*Tradition Design Review Committee
Architectural Review*

Regarding: Capstone – The Cottages Landscape Modification

Re: CAPSTONE COTTAGES - LANDSCAPE BUFFER WALL MODIFICATION

LA5

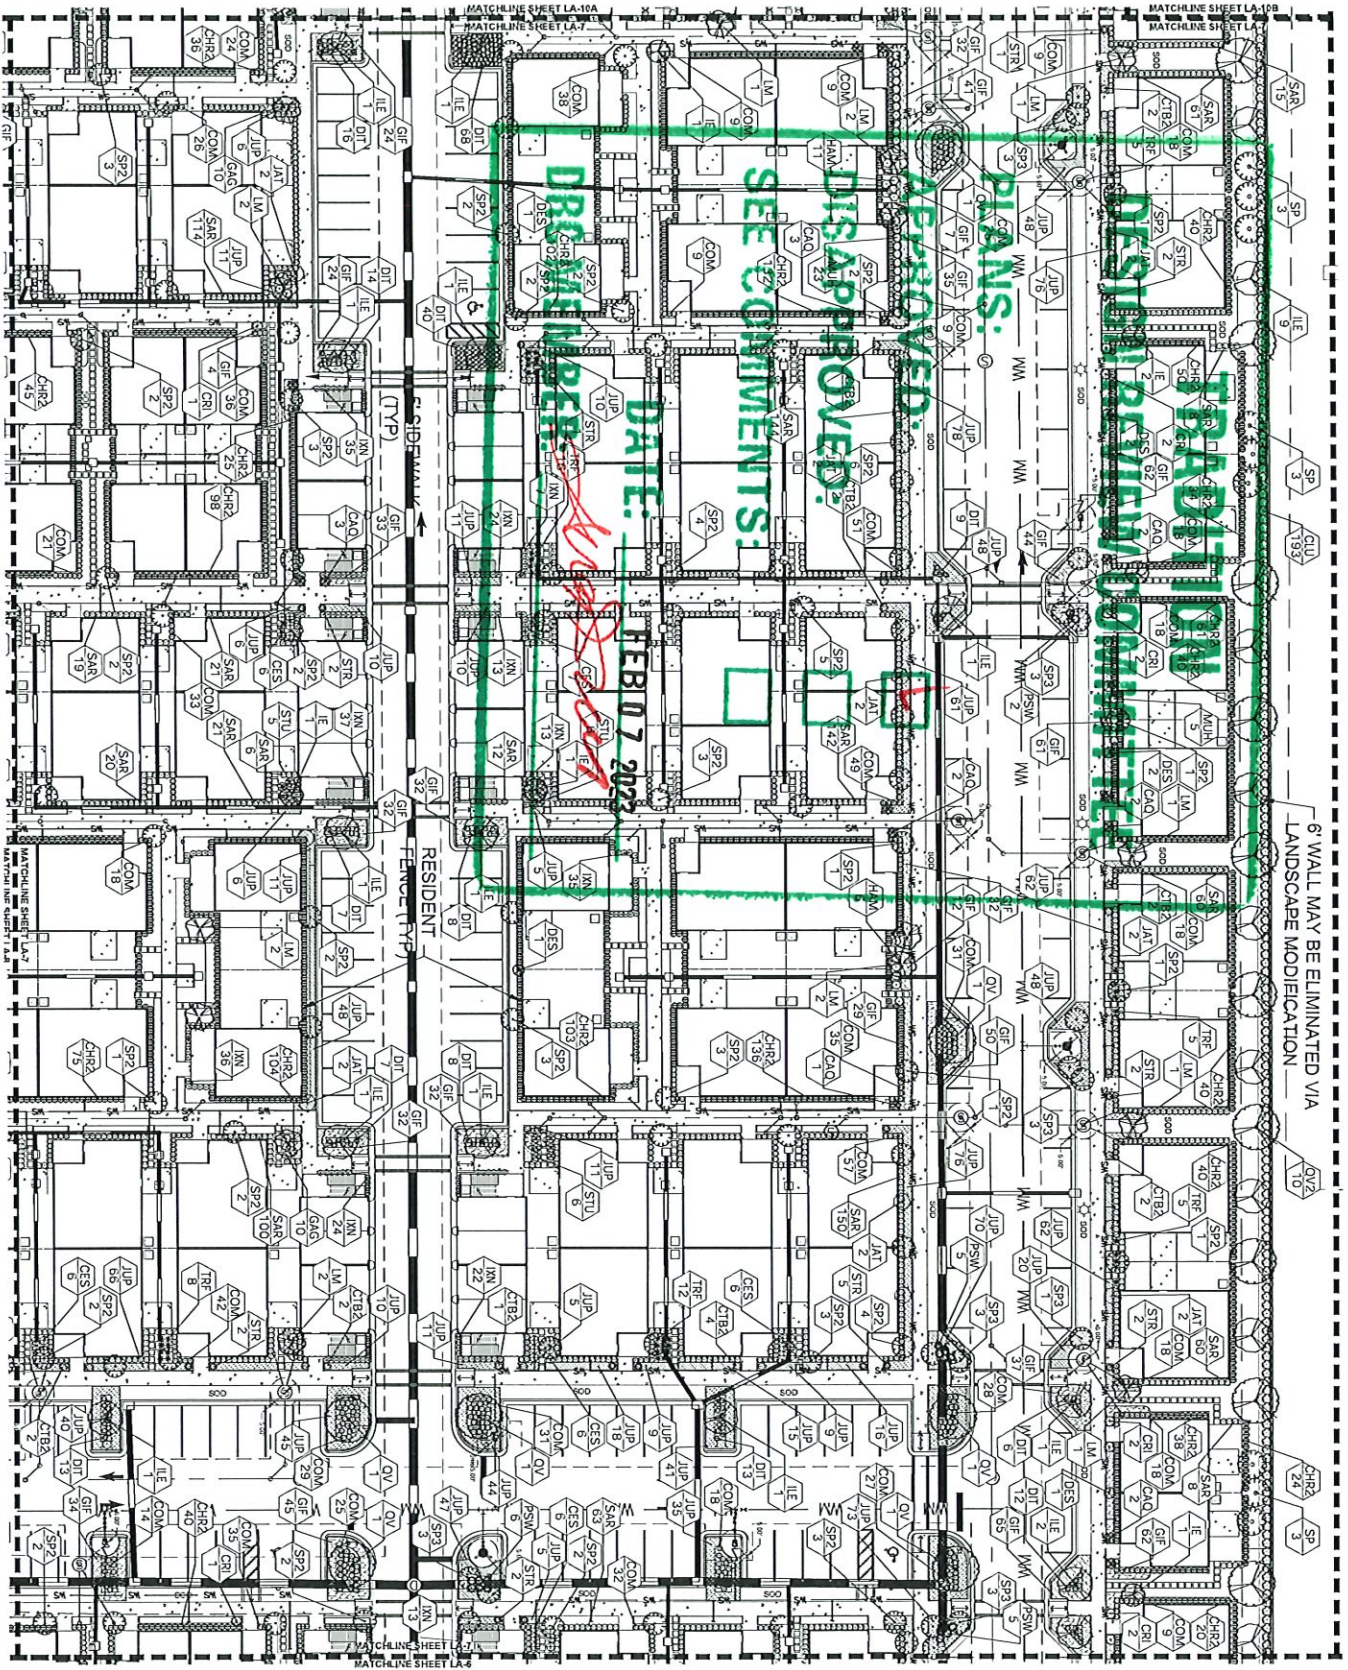
6 WALL MAY BE ELIMINATED VIA LANDSCAPE MODIFICATION
